**GENERAL/DETAILED DISTRICT DEVELOPMENT PLAN**  
**HUNTINGTON RIDGE AT MIDDLETOWN**  
 211, 213, 215 & 217 URTON LANE  
 LOUISVILLE, KY 40223  
 D.B. 8870, PG. 647 D.B. 7766, PG. 550  
 TAX BLDG#: 32 LOTS: 65, 67, 71, 72

**Case No. 8419 - Binding Elements**

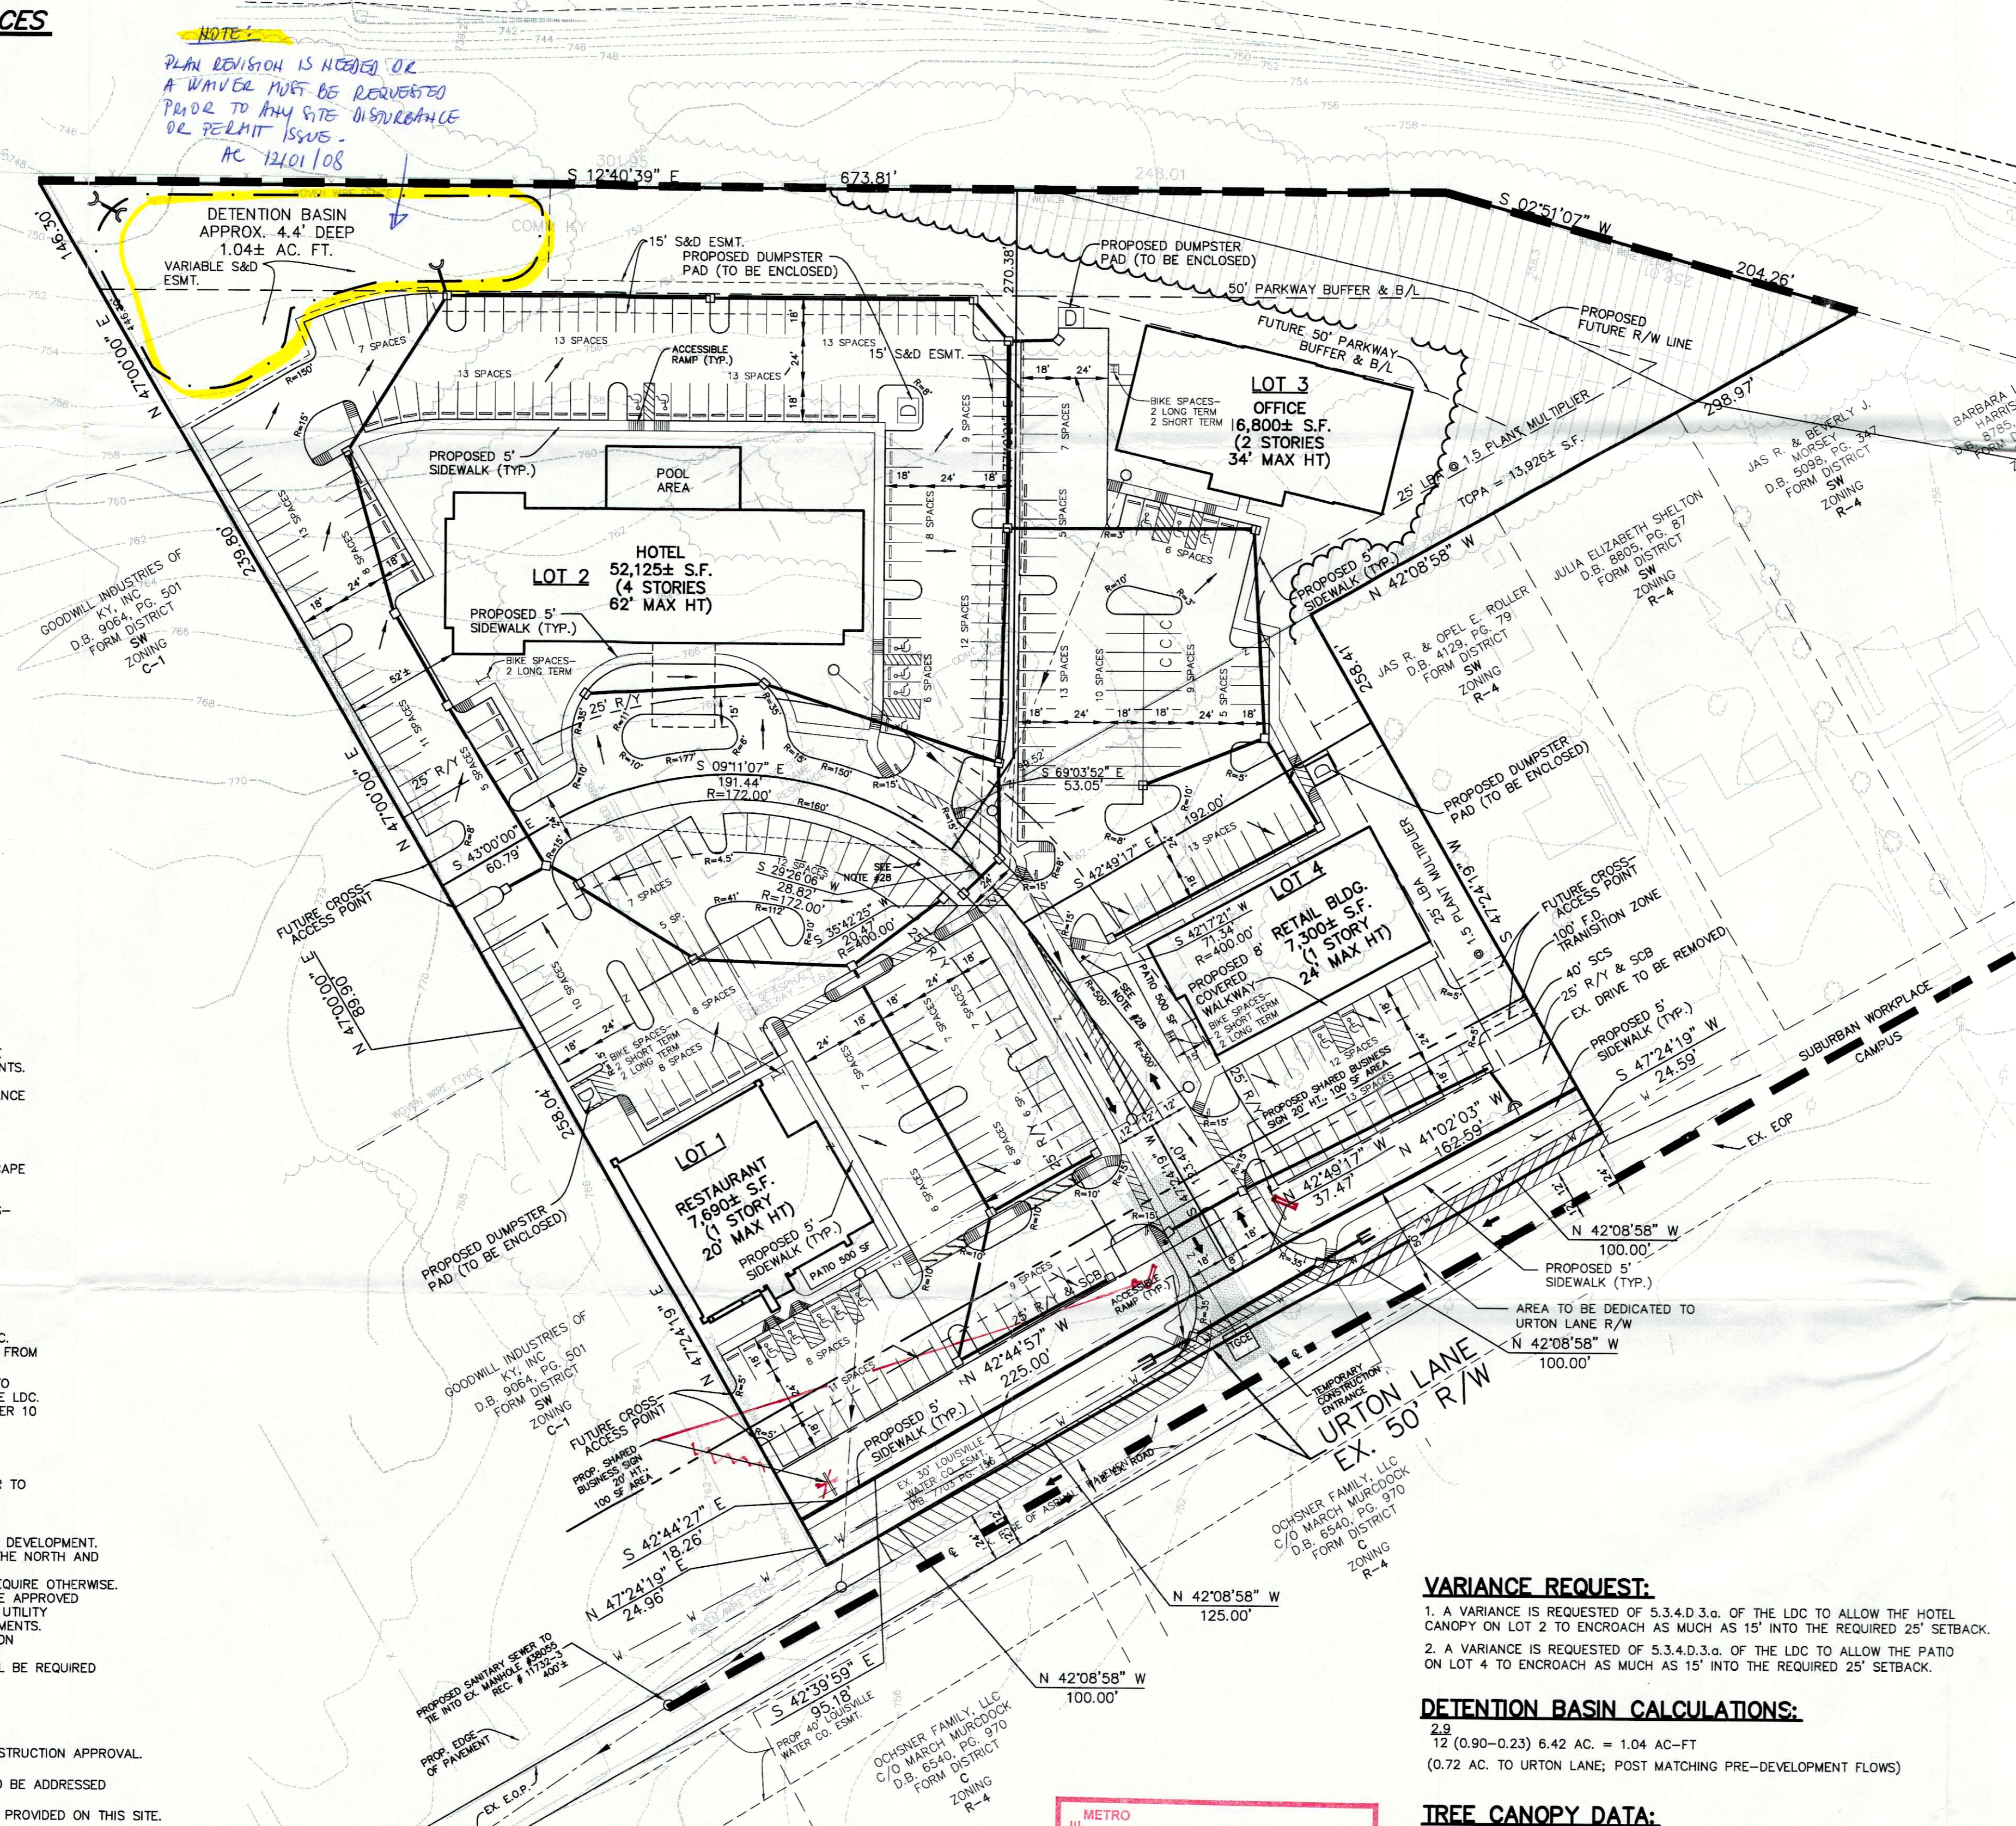
NOTE:  
 PLAN REVISION IS NEEDED OR A VARIANCE MUST BE REQUESTED PRIOR TO ANY SITE DISCUSSANCE OR PERMIT ISSUES.  
 AC 12/01/08
